TO: US and Canada Dealer Principals, Service Managers, Parts Managers and Sales Managers
RE: Recall R157 Volvo XC90 (MY2003 – MY2006) Outer Tie Rod End May Fracture

<h1>VOLVO</h1> <h2>Service Manager Bulletin</h2>				TITLE: Recall 157 Outer Tie Rod End May Fracture		GROUP: 64	NO: 157										
				MODEL YEAR 2003-2006 XC90		ISSUING DEPARTMENT: Warranty

SUBJECT Recall 157 Outer Tie Rod End May Fracture.
REFERENCE: VIDA, SMB 64-157, PB 64-157

Installing the outer tie rod

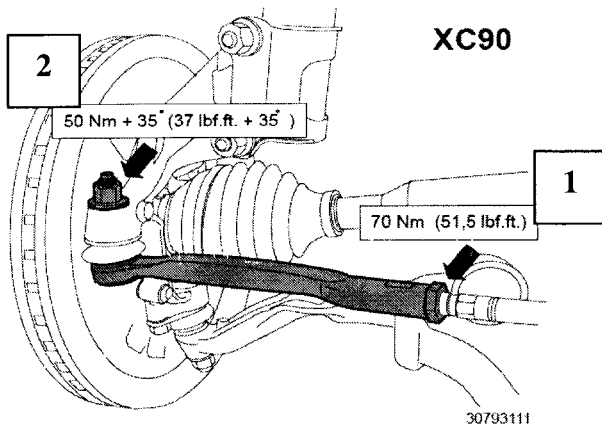
- the outer tie rod on the steering gear **1**. Torque the jam nut to 70 Nm (51.5 ft/lb).
 - The outer tie rod on the wheel spindle **2**. Use a wrench to counterhold the shaft, and tighten to 50 Nm + angle torque to 35° (37 ft/lb + angle torque to 35°).
-
-

Note! It is critical that the proper torque is achieved when installing the outer tie rods; **only hand tools may be used.** Do not use impact tools when installing the outer tie rod!
